NUCLEAR REGULATORY COMMISSION

Title: Advisory Committee on Reactor Safeguards

Date: Wednesday, September 9, 2015

ACRS Full Committee Meeting: Containment Protection and Release Reduction Rulemaking

Figure 3-3: Uncertainty Bounds for Individual Latent Cancer Fatality Risk

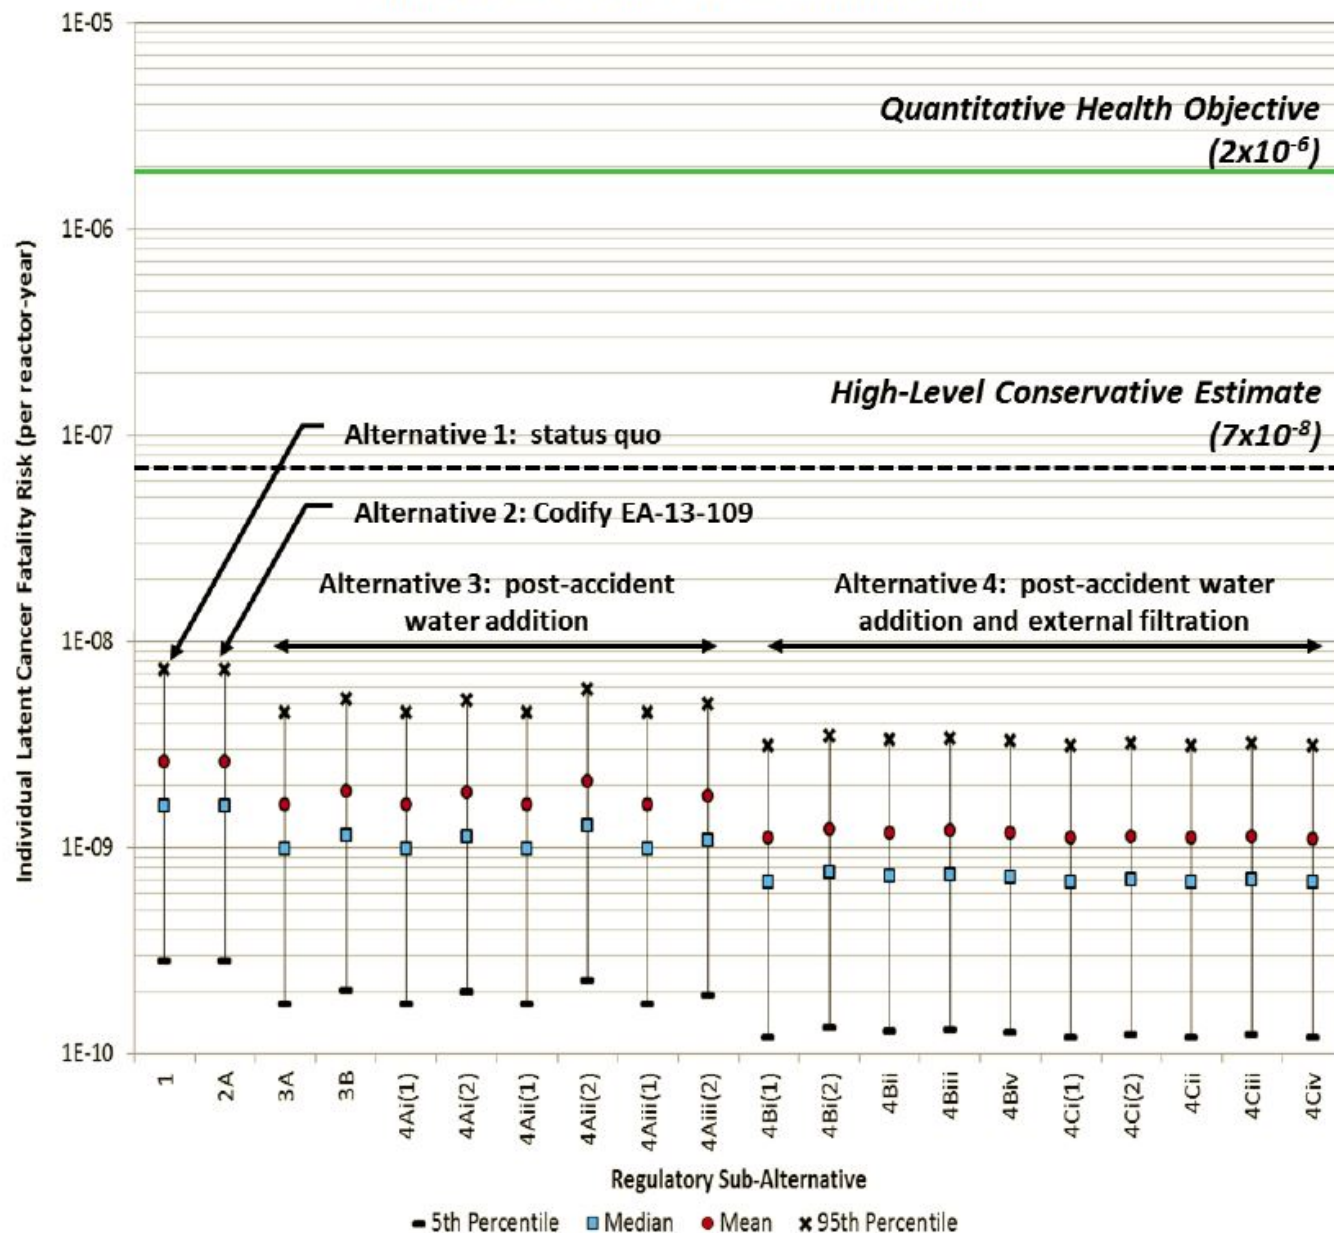
The Regulatory Analysis of Alternative 4 miscalculated QHO benefits and essentially neglected all non-QHO benefits.

Regulatory Analysis unrealistically assumed that protective actions would be nearly 100% reliable in evacuating individuals before they were exposed to significant levels of radioactivity.

Figure 4-24: CRF for Conditional ILCF Risk (0-10 mi) for Evacuation Sensitivity Calculations for BWR Mark I MELCOR Case 49

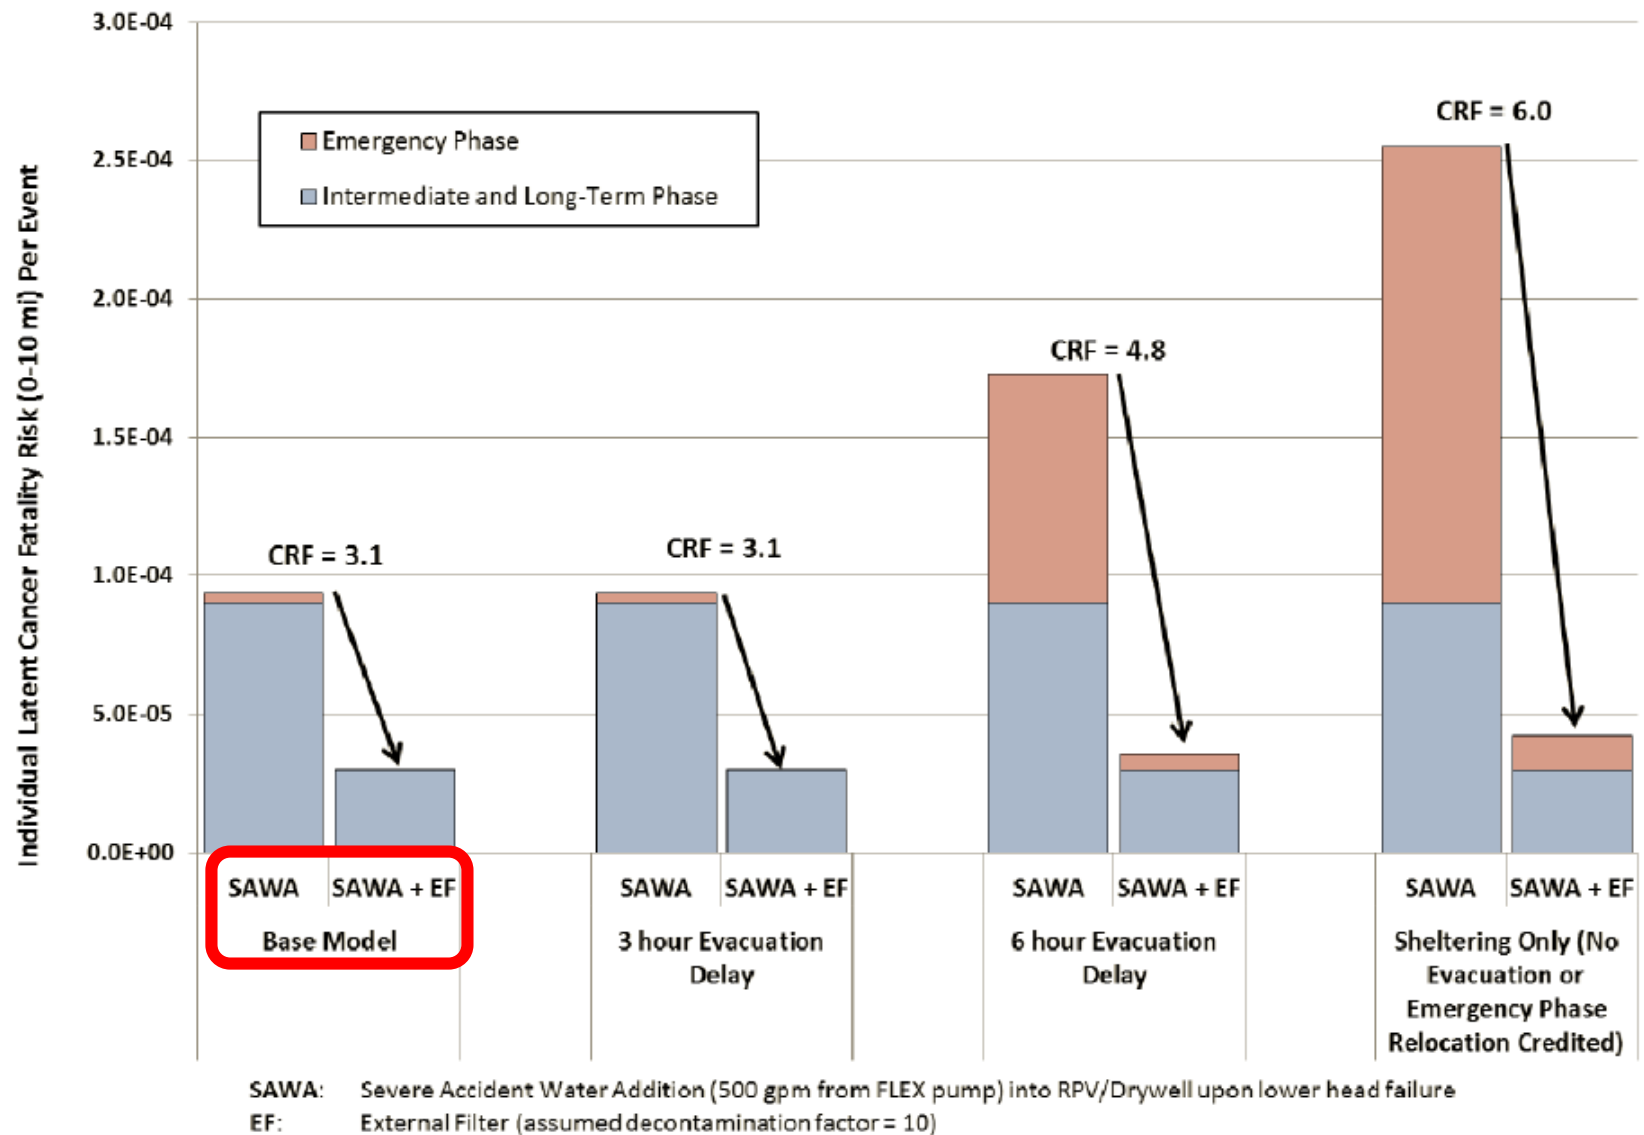
8 This is Figure 4-24 from the draft
9 regulatory basis, and it provided the consequence
10 reduction factors for Alternatives 3 and 4 under four
11 different emergency evacuation scenarios. The staff
12 decided that CRFs of 3.1 to 6.0 were not enough to
13 justify the cost of Alternative 4. I urge you to keep
14 this point in mind because I'll return to it pretty
15 soon.

20 Slide nine, please. Last, the draft's own
21 Figure 24, dash 24, shows the health benefits of
22 adding a filter. The short columns to the right are
23 SAWA and filter, plus the filter. They lead to a
24 dramatic drop in latent cancer fatality risk,
25 especially as evacuation time increases which are the

ILCFs Not Determined Realistically

As Figure 4-24 in the Regulatory Analysis shows, the NRC's base model assumed protective actions (i.e., evacuations) would be ~100% successful.

Figure 4-24 also shows that less than 100% success results in larger individual latent cancer fatality risks during the emergency phase than for ALL phases examined by the base model.

The Regulatory Analysis's conclusion relies on a non-validated assumption of ~100% success.

Figure 4-20: Mark I RPV Water Level for Case 9-IVR

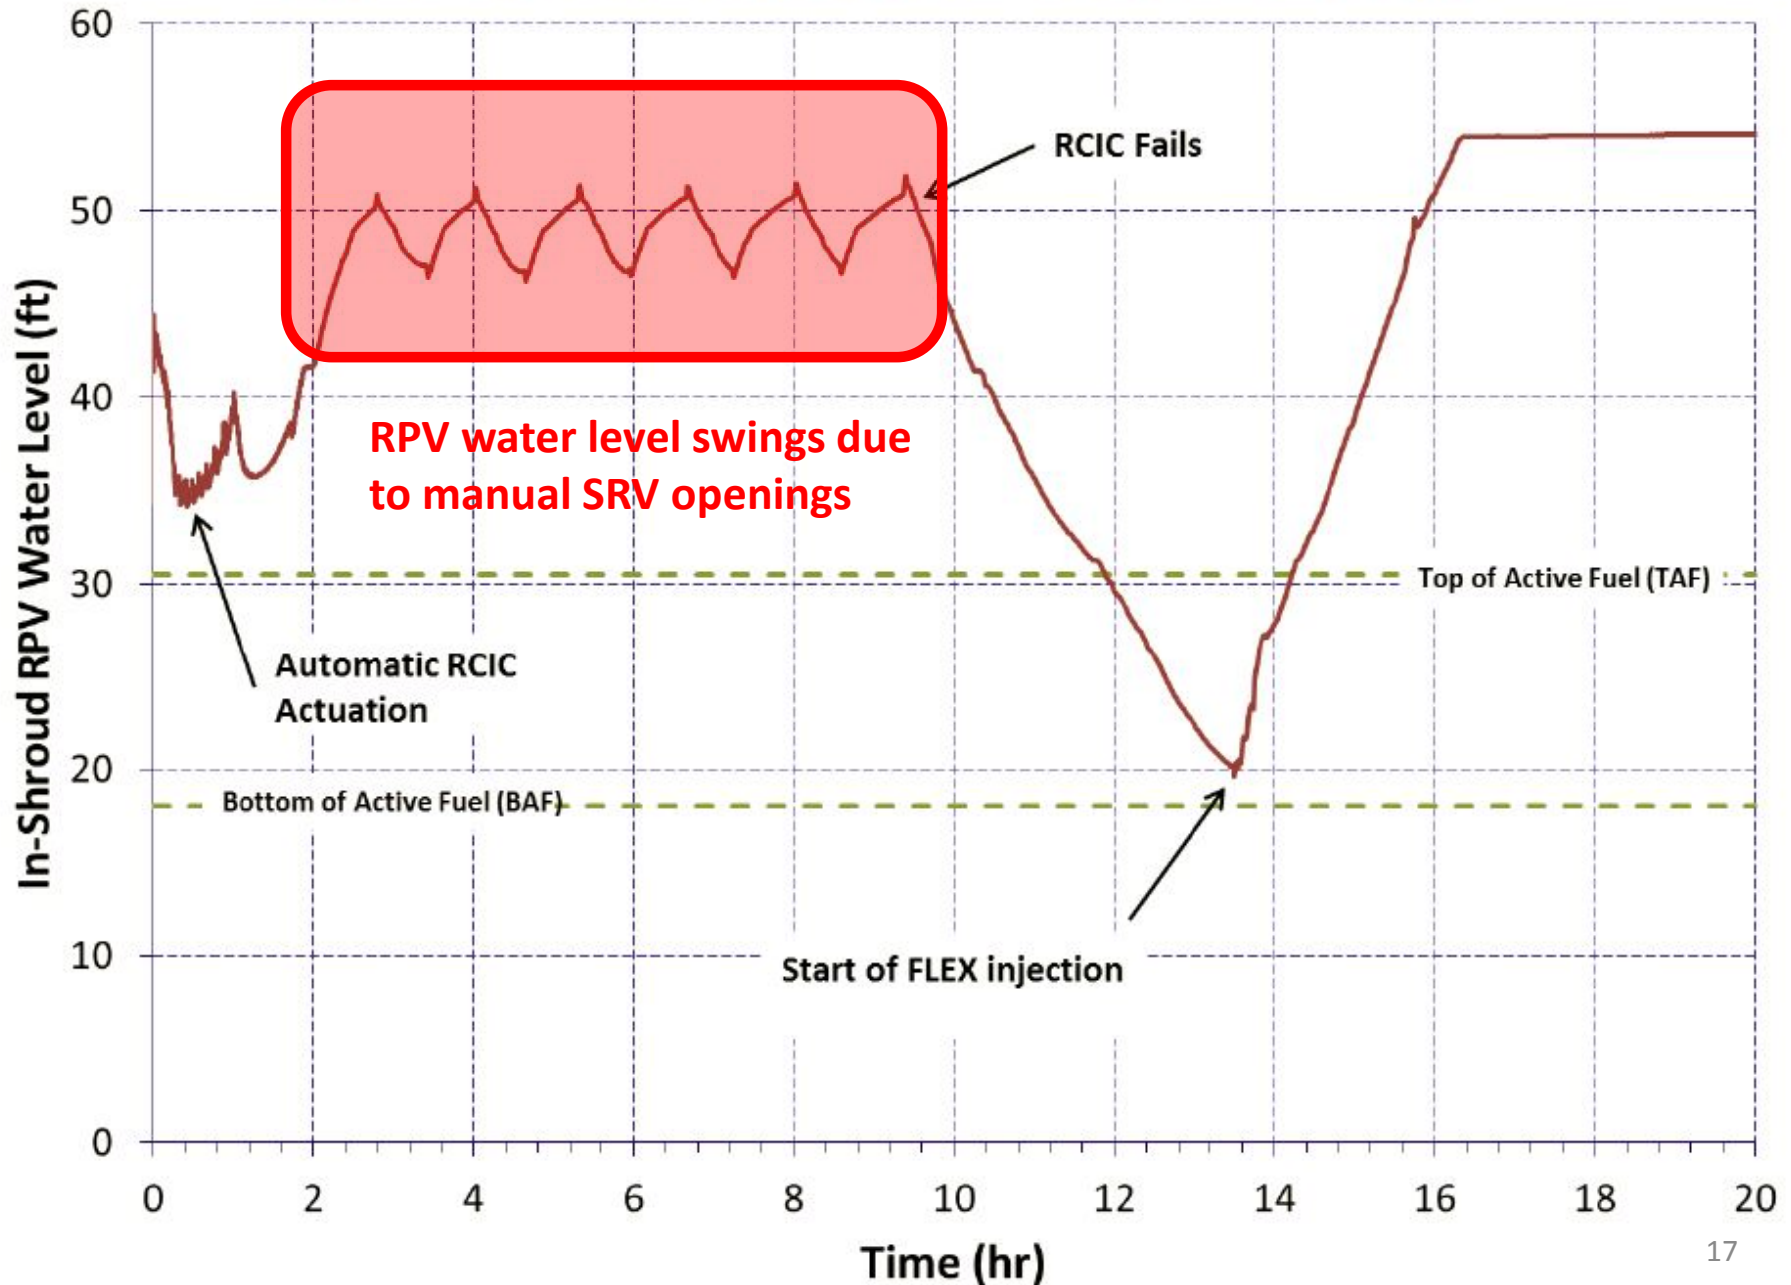
But the SRVs require more than dc power in order to be manually opened.
